Project	IEEE 802.16 Broadband Wireless Access Working Group < http://ieee802.org/16 >	
Title	Enhancement of association using SCAN-REQ/RSP	
Date Submitted	2004-05-17	
Source(s)	Sungjin Lee Yeongmoon Son Jungje Son Changhoi Koo Samsung Electronic, Suwon P.O.Box 105, 416, Maetan-3dong, Yeongtongl-gu, Suwon-i., Gyeonggi-do, Korea 442-742	Voice : +82-31-279-5091 Fax : +82-31-279-5130 steve.lee@samsung.com ym1004.son@samsung.com jungje.son@samsung.com chkoo@samsung.com
Re:	This contribution is response to call for contribution about IEEE802.16e-D2	
Abstract	This document proposes the scheme enhancing association operation with SCAN-REQ/RSP	
Purpose	Discuss and Adopt the advanced feature for periodic ranging in sleep mode in the IEEE802.16e group.	
Notice	This document has been prepared to assist IEEE 802.16. It is offered as a basis for discussion and is not binding on the contributing individual(s) or organization(s). The material in this document is subject to change in form and content after further study. The contributor(s) reserve(s) the right to add, amend or withdraw material contained herein.

Enhancement of Association using SCAN-REQ/RSP

**Figure E.2—Example BS advertisement and scanning (with association)
by MSS request**

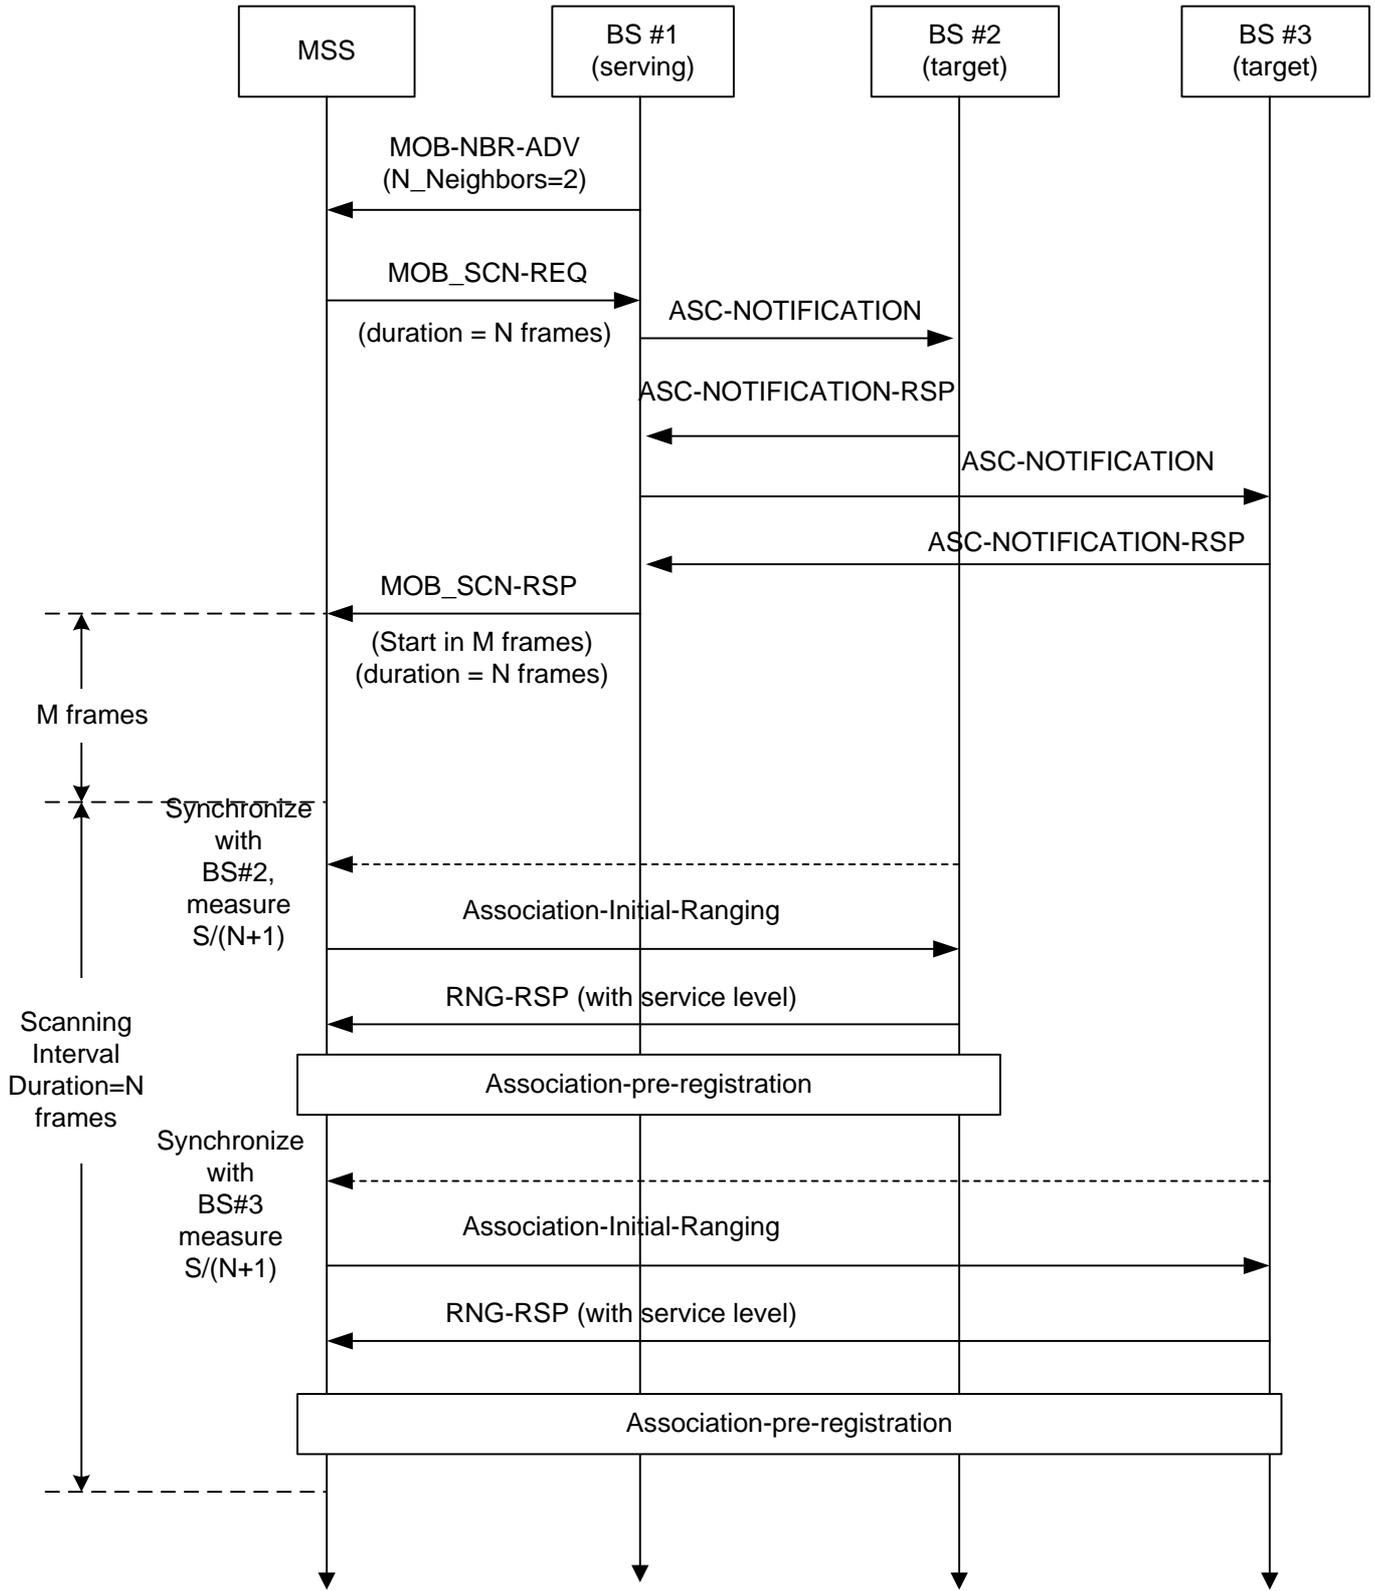
Therefore we propose fast access scheme for association operation in order to allow MSS fast access to target BS. A modified SCN-REQ and SCN-RSP message are proposed to enhance MSS operation of association during Scan Interval. SCN-Notification and SCN-Notification-RSP messages are also proposed to inform target BSs of the MSS information.

A MSS trying association can access to target BS with fast UL ranging IE same as handoff case with above proposed messages and scenario.
